Application for Works Approval

Works Approval Number	W6504/2021/1
Applicant	Norton Gold Fields Pty Limited
ACN	112 287 797
File Number	DER2018/001042-4
Premises	Binduli North Minesite Legal description Mining tenements M26/115, M26/243, M26/387, M26/420, M26/430, M26/445, M26/446, M26/447, M26/468, M26/474, M26/629, M26/833
Date of Report	22 July 2021
Decision	Works approval granted

Figure 5: Heap leach groundwater monitoring bores

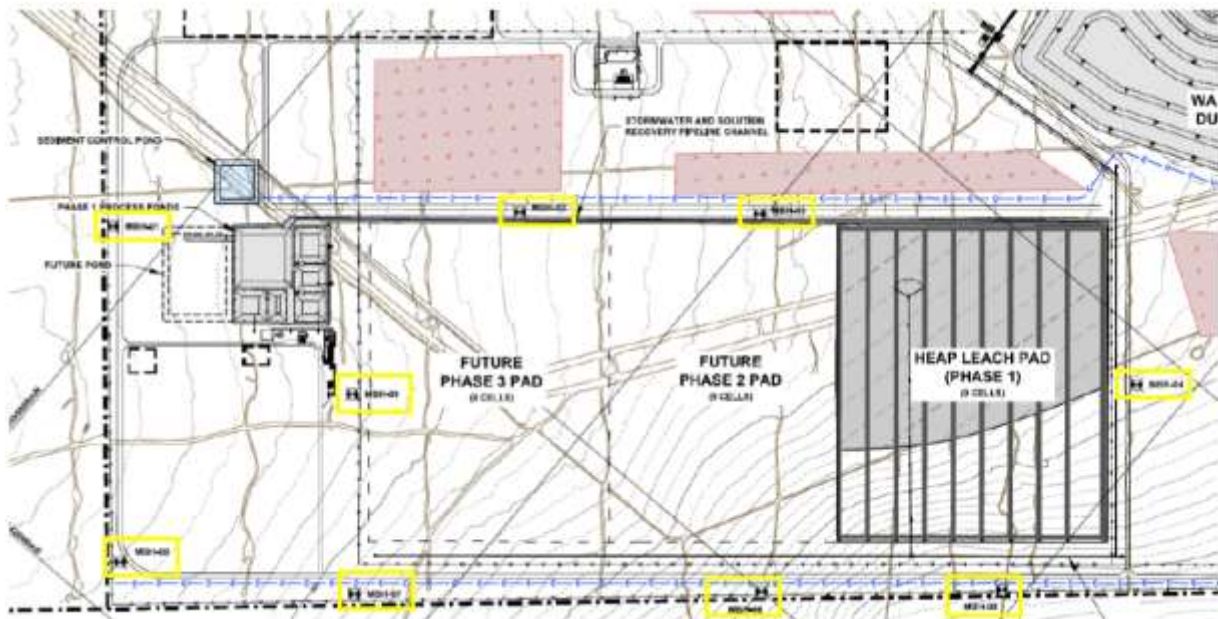
20. (c)	Please amend to read: <i>The ambient groundwater monitoring results obtained during time limited operations under Table 8 Schedule 2 with a comparison to the baseline ambient groundwater conditions.</i>	No changes made – the monitoring of groundwater parameters during time-limited operations need to establish a baseline groundwater parameter level to then be compared with the relevant guidelines. This is to ensure that other uses of the resource are not impacted by the activities.
Schedule 1. Figure 1. Premises Map	Please replace with updated map as provided	Changes made.
Schedule 1. Figure 2. Key Infrastructure Map	Please replace with updated map as provided	Changes made.
Schedule 1. Figure 3. Monitoring Bores Map	Please replace with updated map as provided	Changes made.
